**REPORT TO  
PLANNING AND DESIGN COMMISSION  
City of Sacramento**

**REVIEW & COMMENT  
June 2, 2016**

**Subject: Land Park Commercial Center (P15-048) - Review & Comment**

FLOOR PLAN  
Shops 3

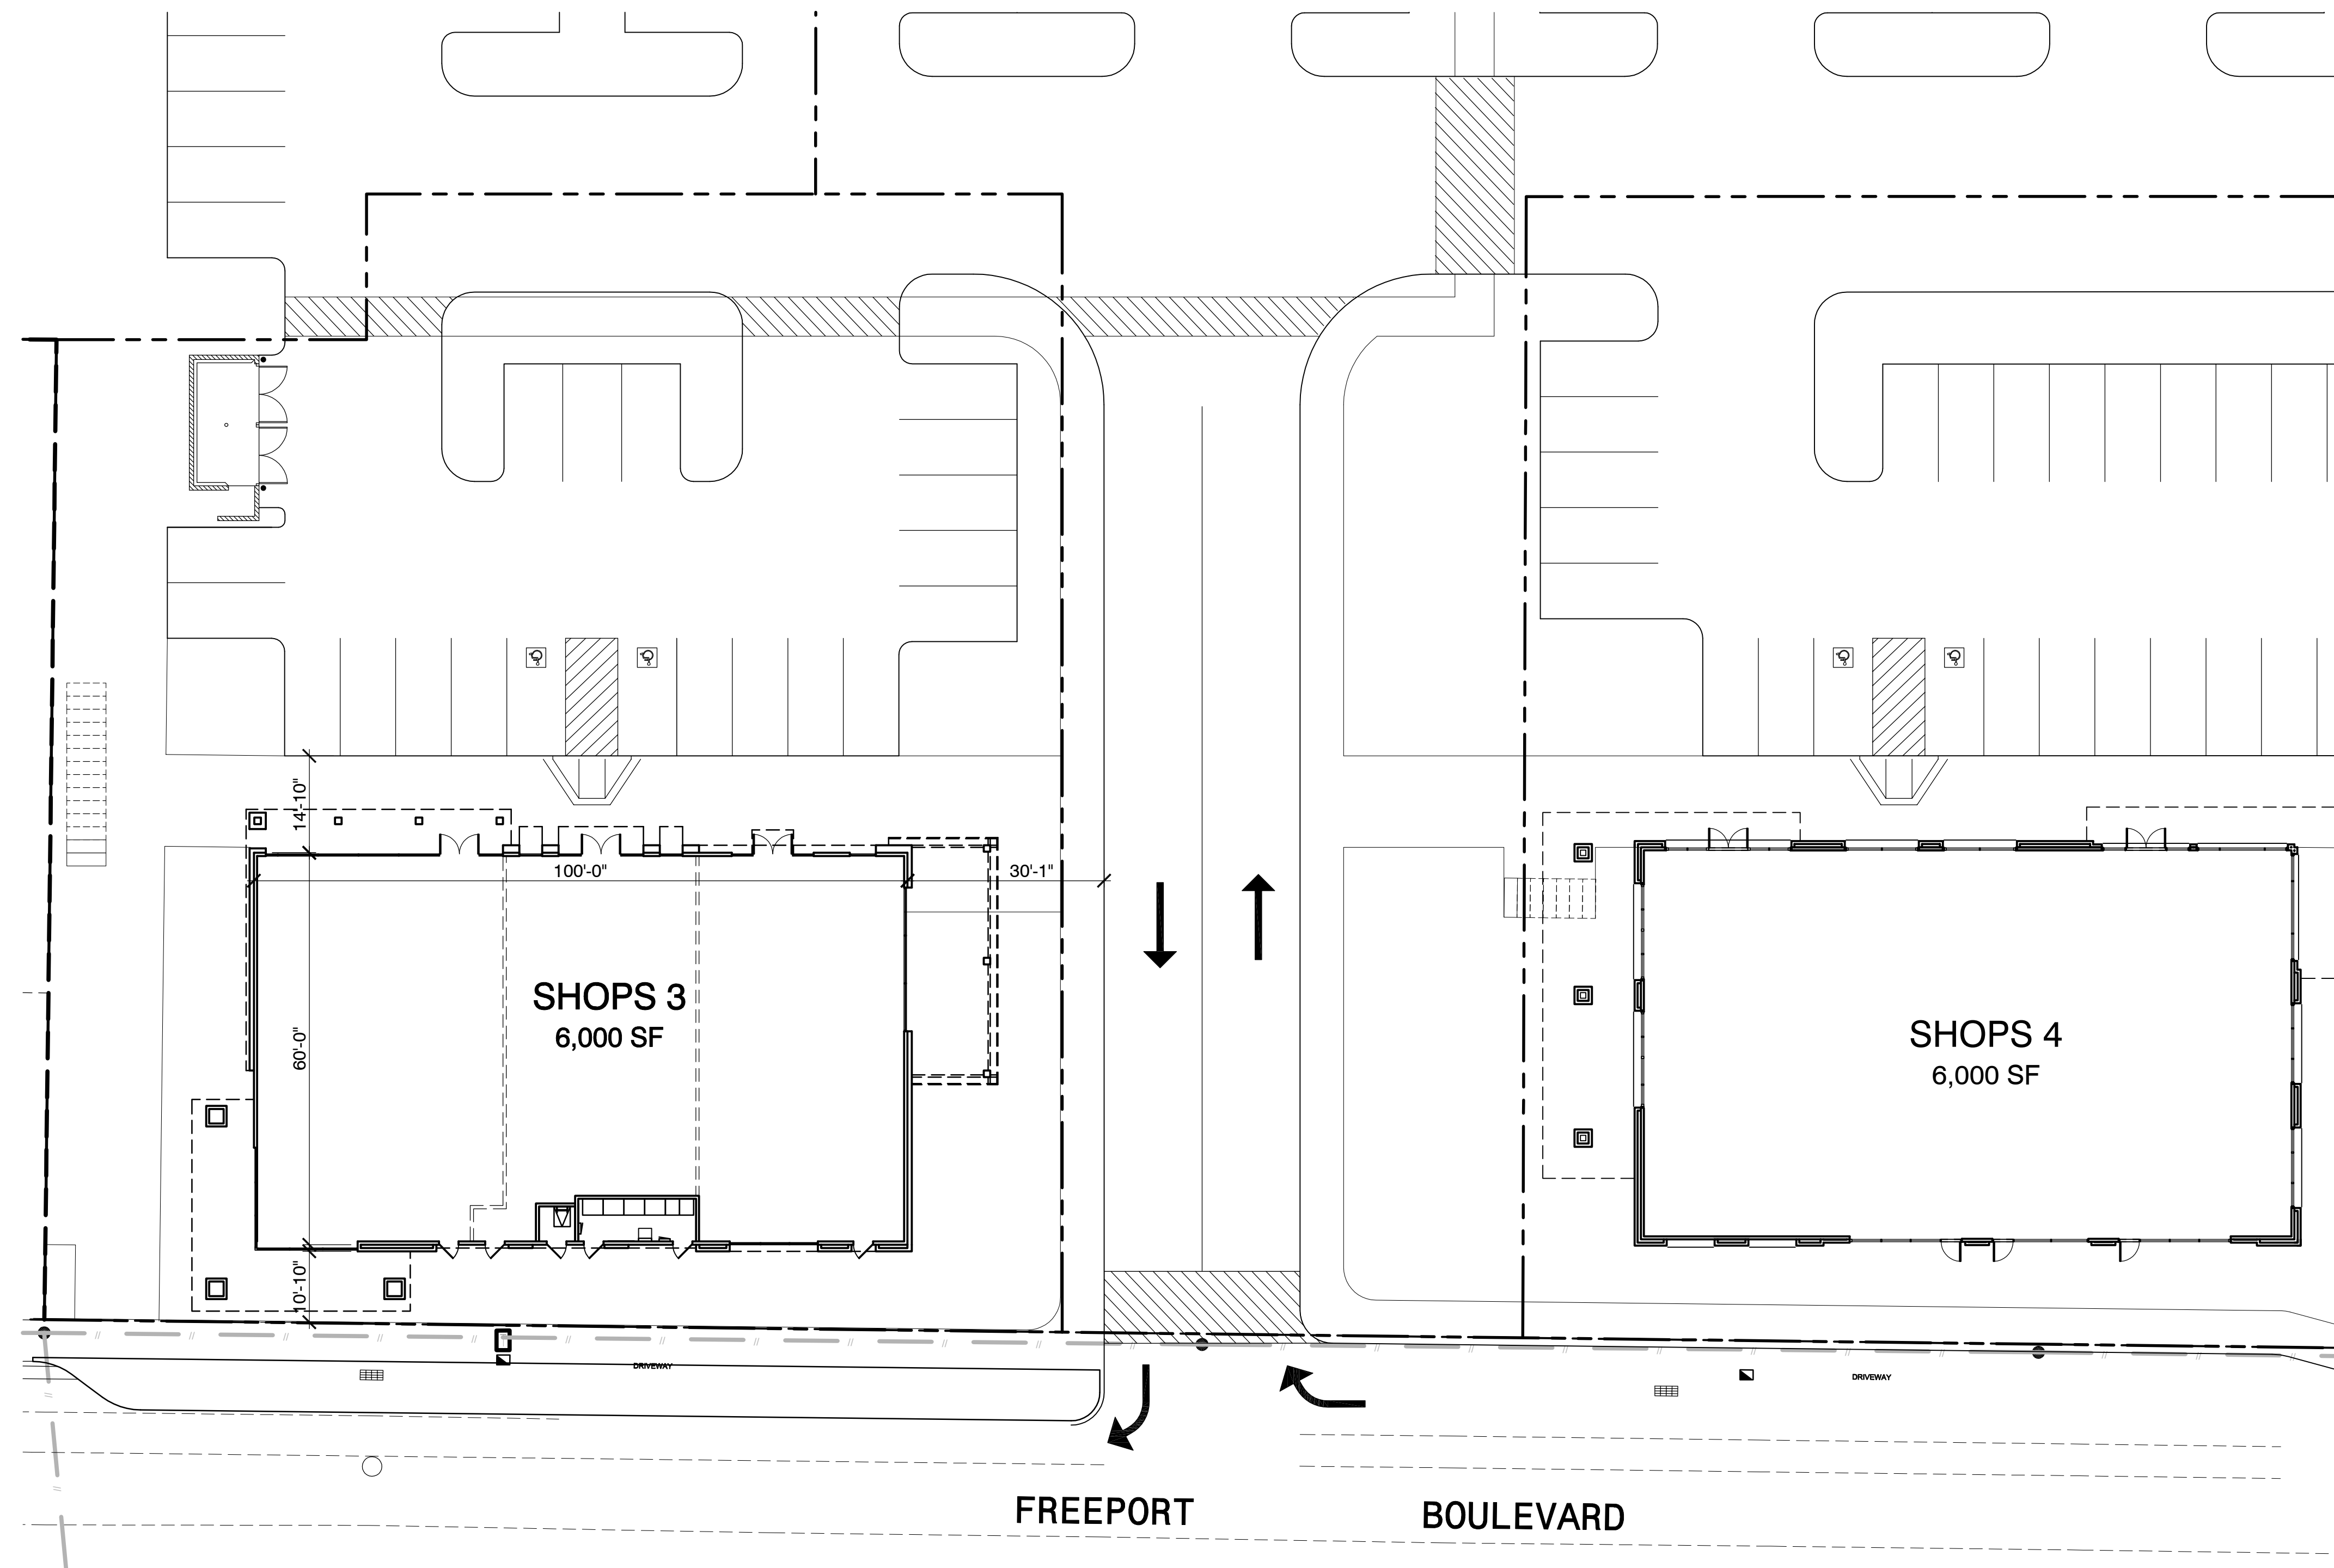
- 1) Modify the design and/or the positioning of the buildings, such as those designated "Shops 3" and "Shops 5", so that entrances face Freeport Boulevard and Wentworth Avenue, and re-orient the location of the parking areas relative to buildings to allow direct pedestrian access to buildings from the street. This would remove the "walled fortress" feeling of the development and conform to the 2035 General Plan by
